EQUIPMENT/FURNISHINGS - OPTION FOR LARGER HEADSET HOOK

MODEL	SERIAL NUMBERS
525C (CJ4)	-0001 thru -0304

SB525C-25-05
Page 1 of 6

Figure 1. Headset Hook Installation (Sheet 1)

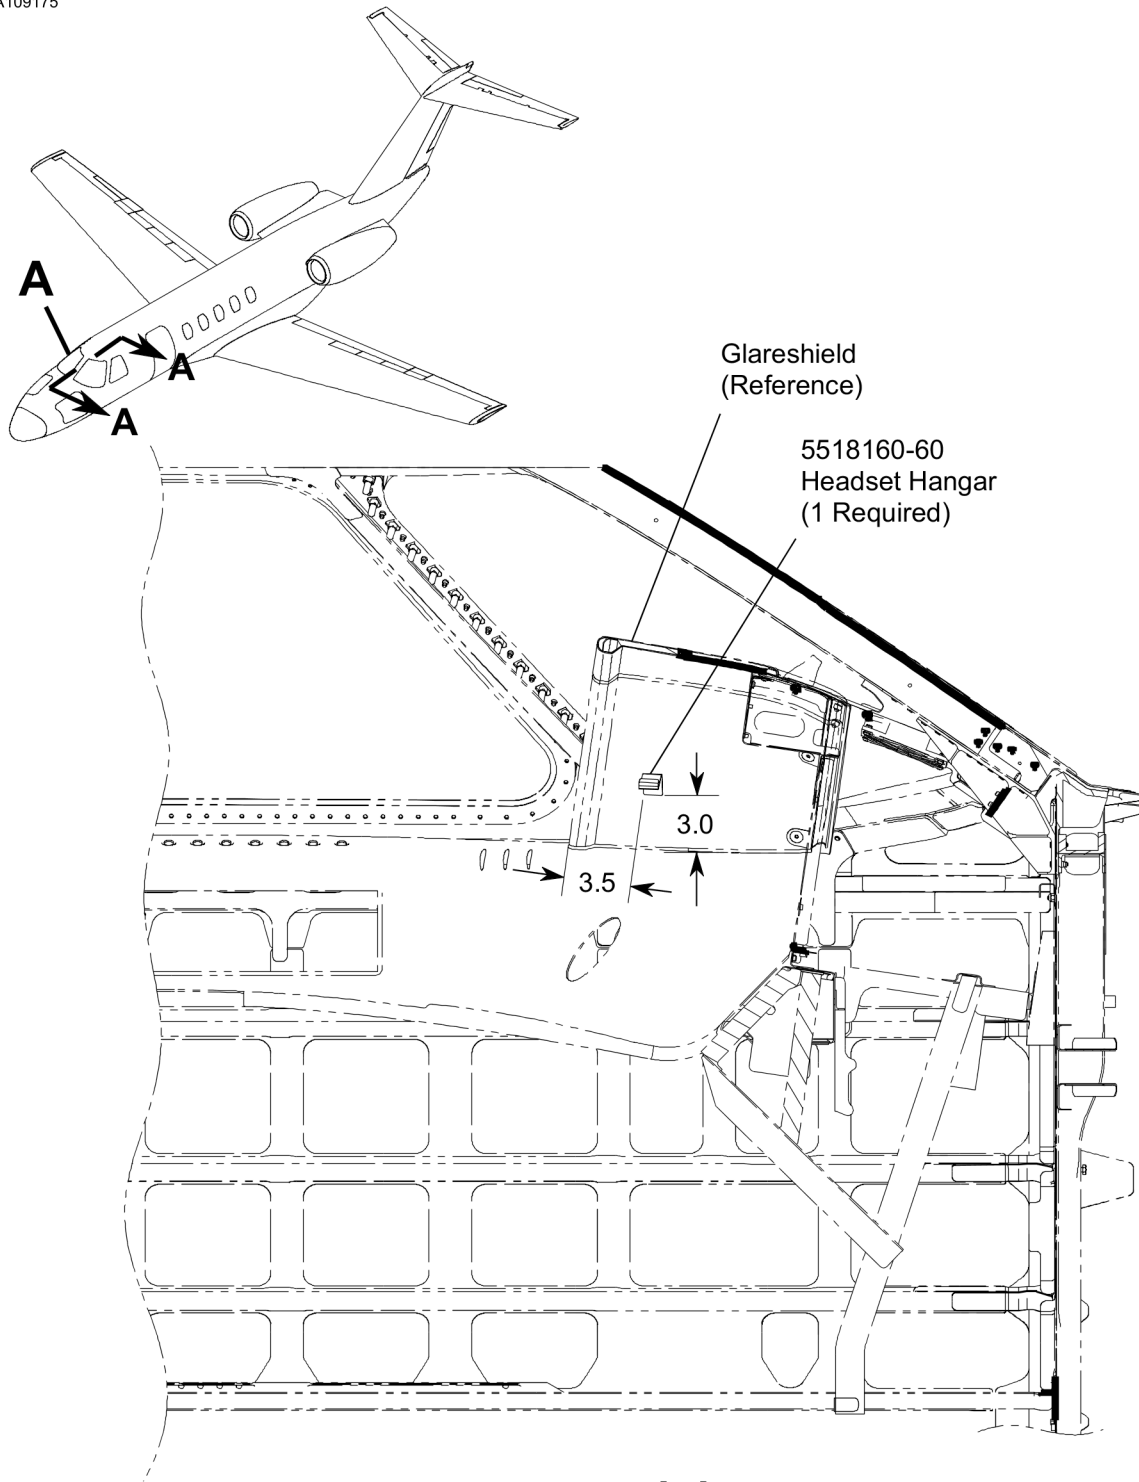
2. (Refer to Figure 1, Detail A and View A-A.) Install two 5518160-60 Headset Hangars.
 - A. Lightly abrade the mating surface of the glareshield and the 5518160-60 Headset Hangar.

- E. Install the 5518160-60 Headset Hangar on the left and right glareshield.
 - (1) Make sure the hook portion of the headset hangar is level.
 - F. Wipe away excess adhesive with isopropyl alcohol.

3. (Refer to Figure 1, Detail A and View A-A.) Do Step 2.A. thru 2.F. to install the 5518160-60 Headset Hangar.
4. Remove the maintenance warning tags and connect the airplane battery.
